UNITED STATES PATENT AND TRADEMARK OFFICE

APPLICATION NO.	FILING DATE	FIRST NAMED INVENTOR	ATTORNEY DOCKET NO.	CONFIRMATION NO.
10/536,576	02/06/2006	Piotr Szwaykowski	TROLOGY 02.02	9931
27667 7590 10/02/2009 HAYES SOLOWAY P.C. 3450 E. SUNRISE DRIVE, SUITE 140 TUCSON, AZ 85718				
EXAMINER LEE, HWA S				
ART UNIT 2886		PAPER NUMBER		
NOTIFICATION DATE 10/02/2009		DELIVERY MODE ELECTRONIC

Office Action Summary

DETAILED ACTION

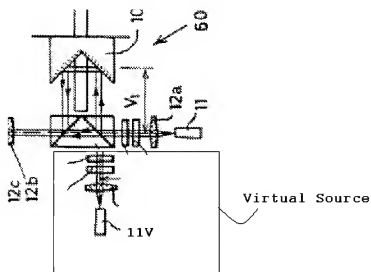
2. Claims 1, 3-11, 13, 14, 16-21, 26-33, 35, 40 and 41 are rejected under 35 U.S.C. 102(b) as being anticipated by Kuchel (US 4,872,755).

Kuchel show an interferometer for measuring optical phase differences (e.g. Figure 6) comprising

a source module (60) configured to generate mutually orthogonally polarized beams of light from spatially separated sources (please see diagram below showing how there is a source (11) and a virtual source (11V) created by the beamsplitter. The source (11) and virtual source (11V) are spatially separated);

an interferometry module (13-16) receiving said mutually orthogonally polarized beams from said source module, and having at least a reference object (14) and a test object (16) for interaction with said beams; and

a simultaneous phase shifting module (68) receiving a portion of said beams from said interferometry module for generating at least two phase-shifted (67b) interferograms substantially simultaneously from said beams.

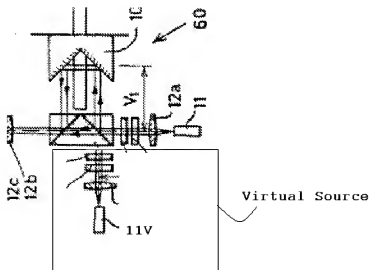
With respect to claim 12, Kuchel does not show the sources being real; however it is well known in the art that there are several ways to make orthogonally polarized beams, including the use of two separate real sources. At the time of the invention, one of ordinary skill in the art would have used two real sources in order to produce beams of high intensity. By using two real sources, the beams have more intensity than the use of a single source where the beam is split in intensity to produce the two beams.

With respect to claims 15, 16, and 34, Kuchel shows the quarter wave plate located in the source, and not positioned between the source module and the reference object, however the relocation of a working part only requires routine skill in the art.

With respect to claims 22-25, Official Notice is taken that the different forms of polarizing beamsplitters are well known in the art and are functional equivalents. At the time of the invention, a skilled artisan would have used calcite for its quality optical properties, would have used a cube splitter for low cost, and would have used optical fibers for flexibility.
